FINAL PHASE I
CONTAMINATION ASSESSMENT REPORT
SITE 36-8: CHEMICAL DRAINAGE DITCH

April 1987
Contract Number DAAK11-84-D0016
Task Number 1 (Section 36)
(Version 3.2)

FINAL RESPONSE TO COMMENTS OF
COLORADO DEPARTMENT OF HEALTH

FINAL RESPONSE TO SPECIFIC COMMENTS OF
SHELL OIL COMPANY

Figure 36-8-3
 REGIONAL TOPOGRAPHY
 SITE 36-8
 ROCKY MOUNTAIN ARSENAL

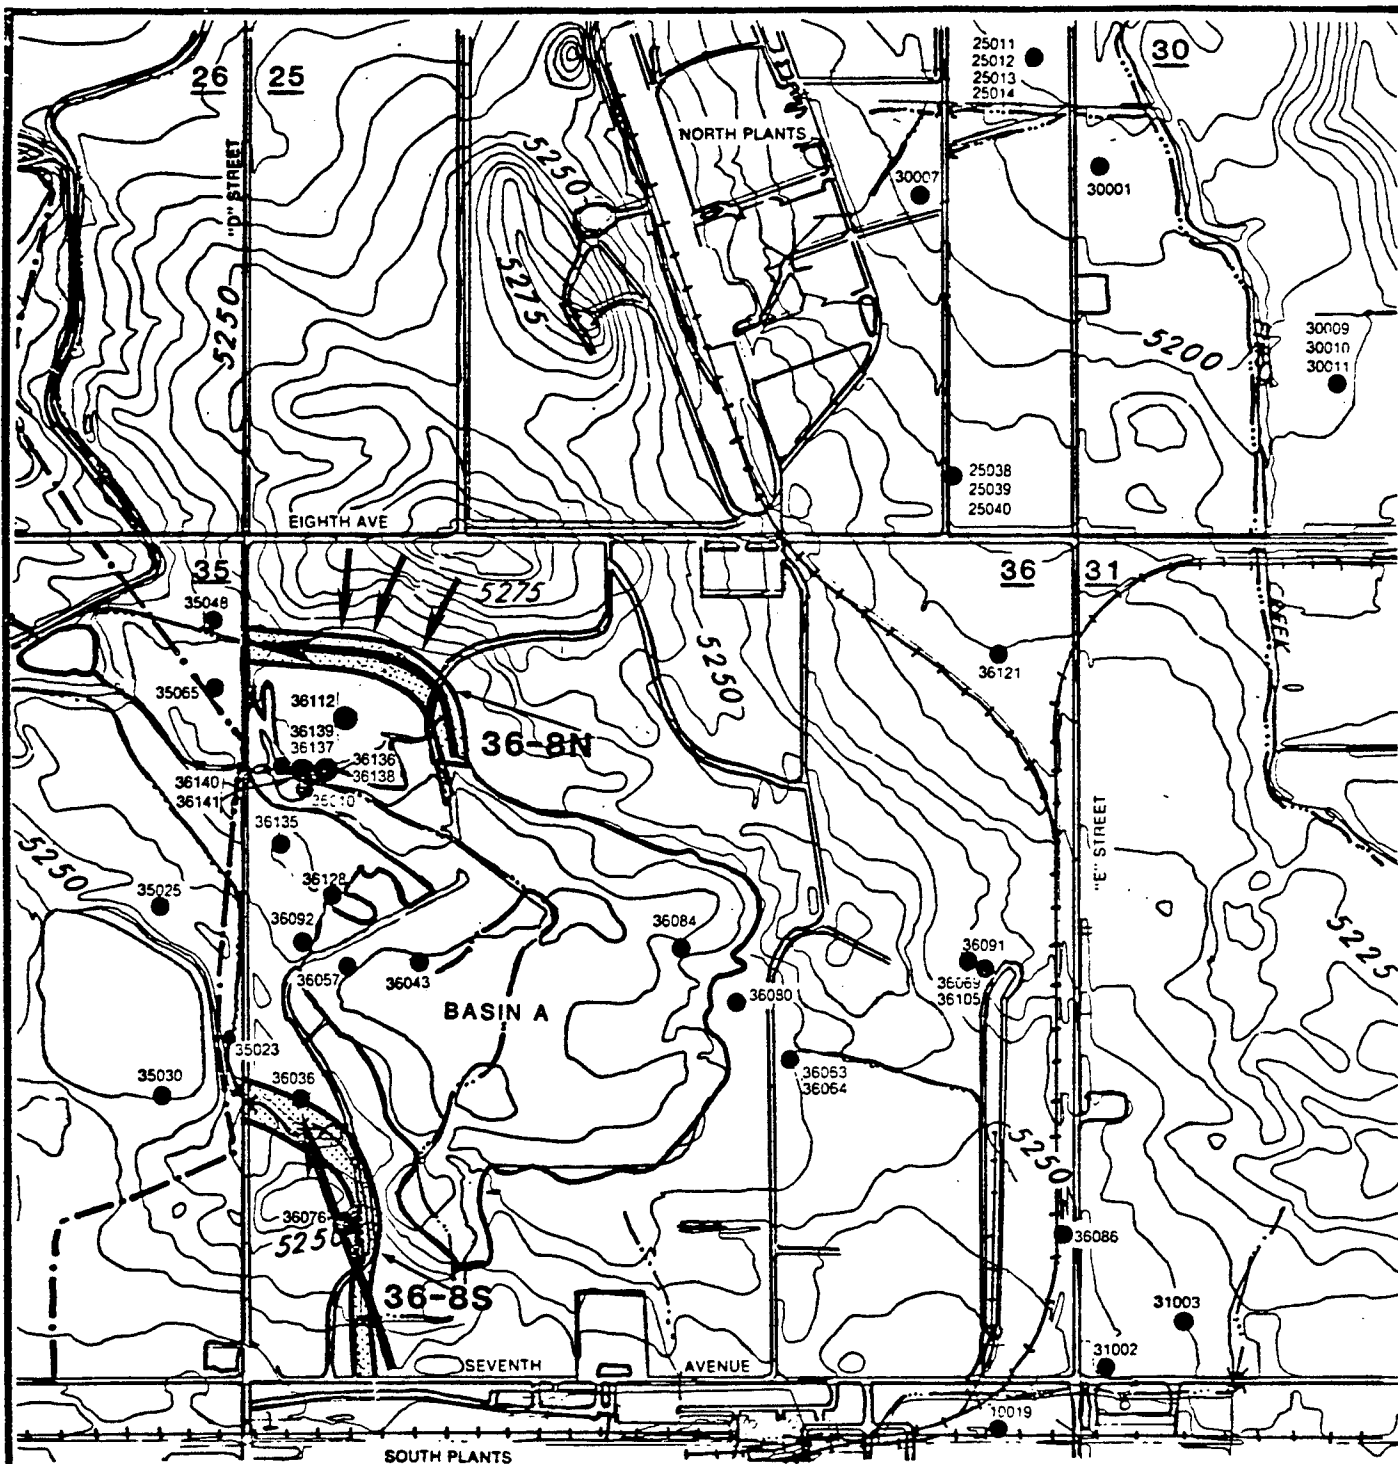
1. P.36-8-17 The monitoring well #1 location on this figure doesn't correlate with Figure 36-5-6. All monitoring wells need to be labeled.

1. P.36-8-17 The monitoring well locations shown on the figures were incorrect in the previous report draft. A new Figure 36-8-3 has been included and shows the correct locations and numbers for relevant wells.

Figure 36-8-6a
 SITE 36-8S, PHASE I INVESTIGATION
 CHEMICAL ANALYSIS RESULTS
 SOURCE: ESE, 1987

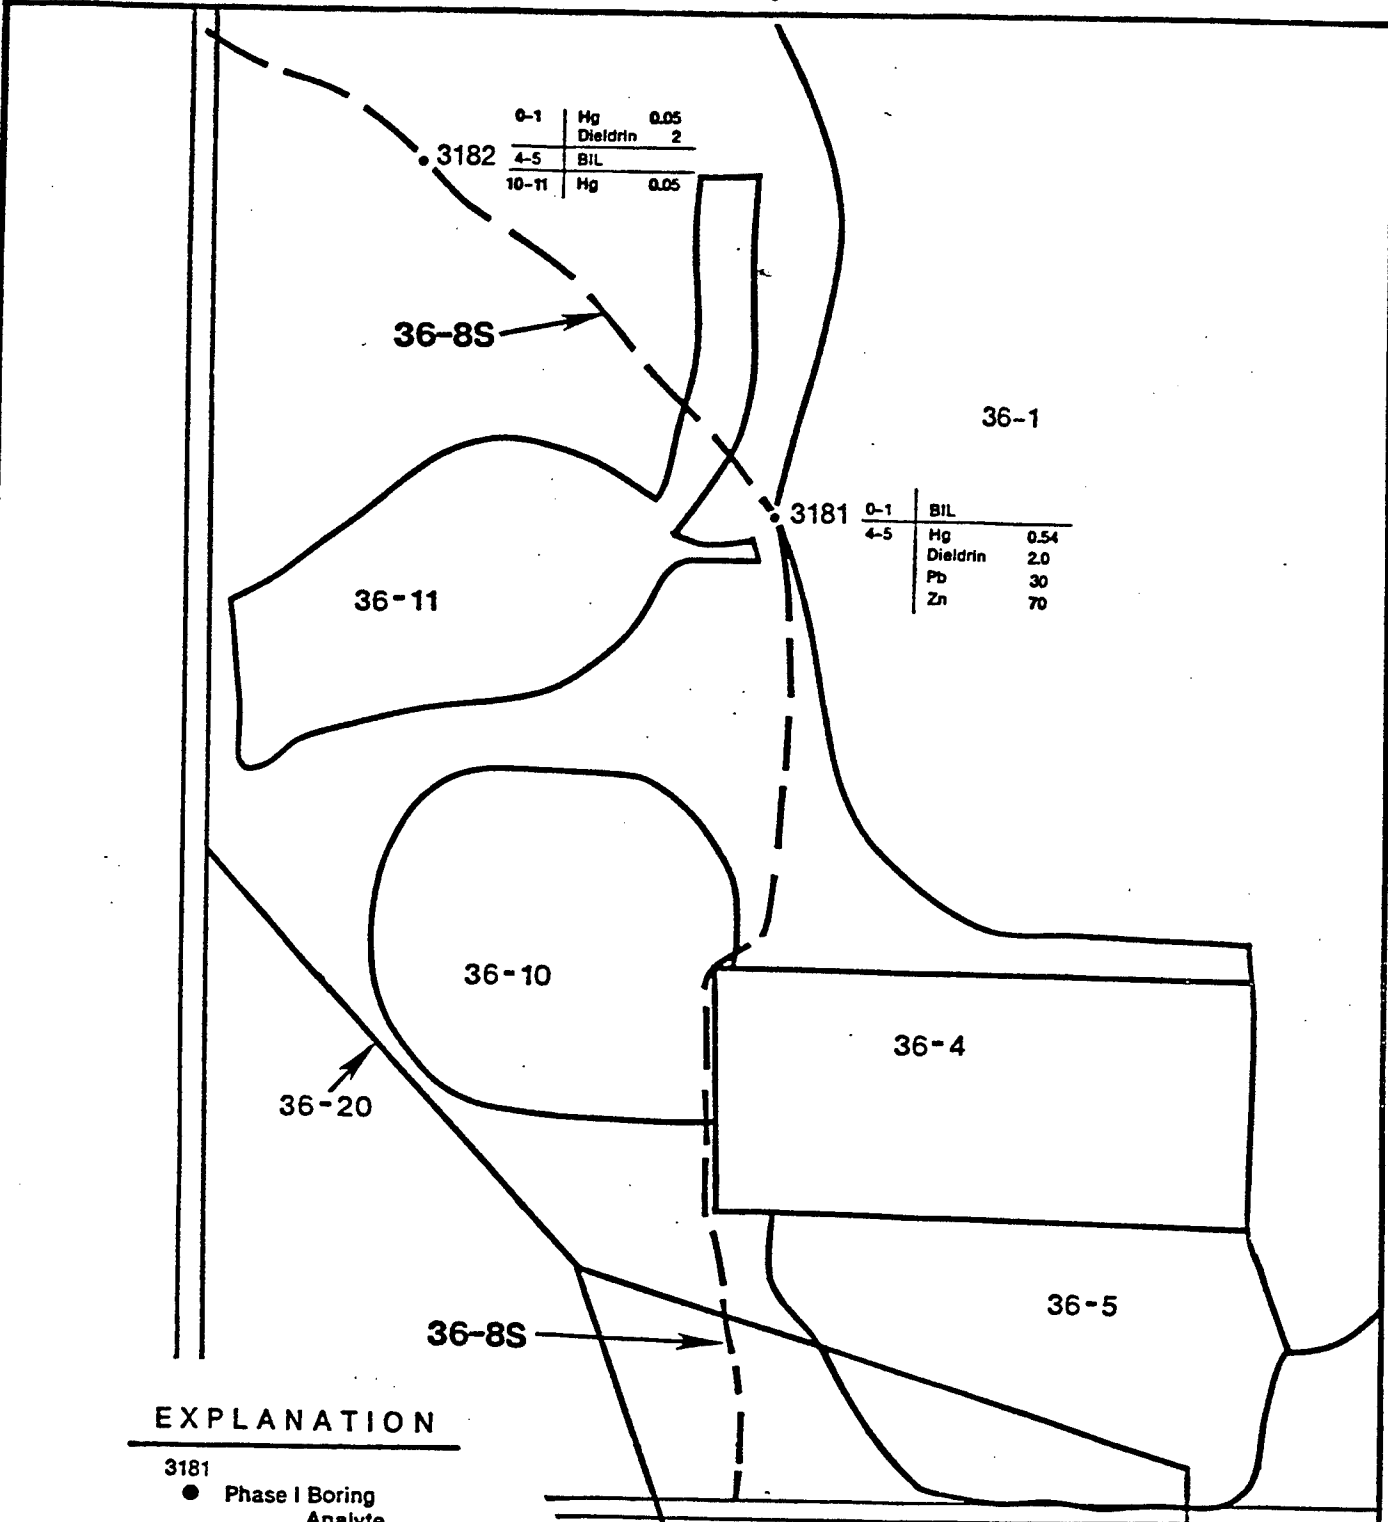
Figure 36-8-6a and Shell Comment No. 2 on Site 36-8 Draft Final CAR. The Army asserts that the "undocumented line" (see 36-20 Task 1, page 9) is being investigated as a part of Task 10. This line was not originally a part of Task 10, and no formal proposal to add this work to Task 10 has ever been received for review. Shell requests that Army provide the relevant documentation for review.

Figure 36-8-7b
SITE 36-8N, PROPOSED
PHASE II INVESTIGATION

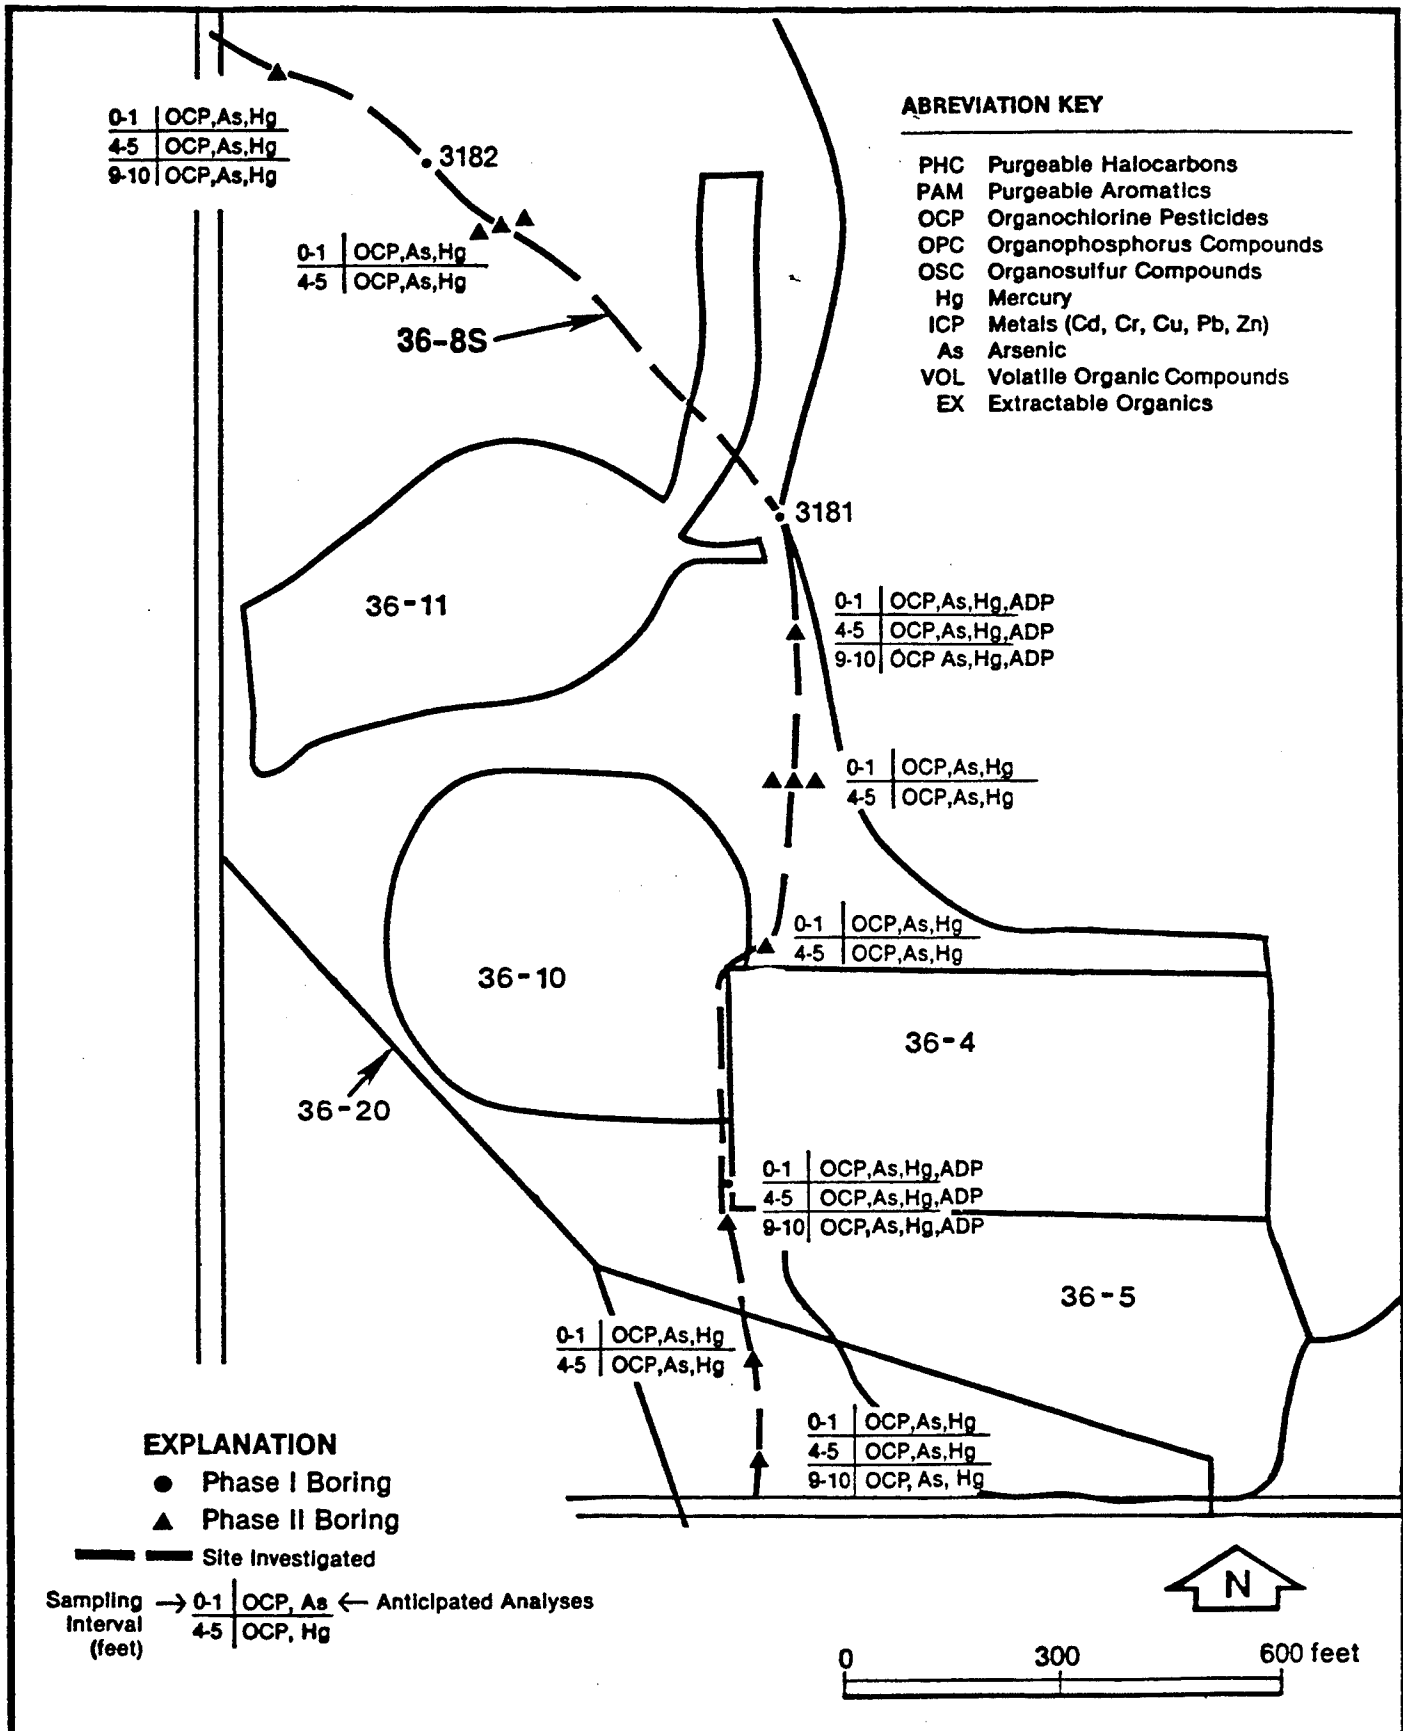
1. Figure 36-8-6B. Why is a transect made at boring 3053 (which was originally in an "uncontaminated" area) when boring 3183 nearby has substantially greater contamination?

1. Figure 36-8-6B. Transects were placed to provide data at the upstream and downstream ends of the ditch which would help define alignment and lateral influence. In this case, symmetry was not assumed, partially because the exact alignment of the ditch is not defined. The boring arrangement shown is thought to be the most economical given site conditions and the questions we are trying to answer.

2. Figure 36-8-7. Boring 3185 should be on this figure. Borings should be placed around 3185.
3. Figure 36-5-1. Volatile analyses are done on all sample intervals except A in source areas 36-8 and 36-20 and on C level (or deepest) in 36-5, 36-10 and 36-12. What are the criteria for deciding which sample interval will be analyzed for volatiles?
4. 36-8-9. Will contamination above or in the gray lime cake be investigated?
5. Table 36-8-5. Wells listed are not identified in Figure 36-8-5a.
6. 36-8-19, first paragraph The suggestion that the contaminants are derived from disposal activities associated with source 36-8 may be true provided fluctuation of the ground water table does not exceed a couple of feet.

2. Figure 36-8-7. Boring 3185 was part of the 36-20 investigation and was mislocated in the field, off the 36-20 alignment. Phase II borings for Site 36-20 are located in this vicinity. Boring 3185 is influenced by an abandoned sewer line nearby, which is being investigated under Task 10.
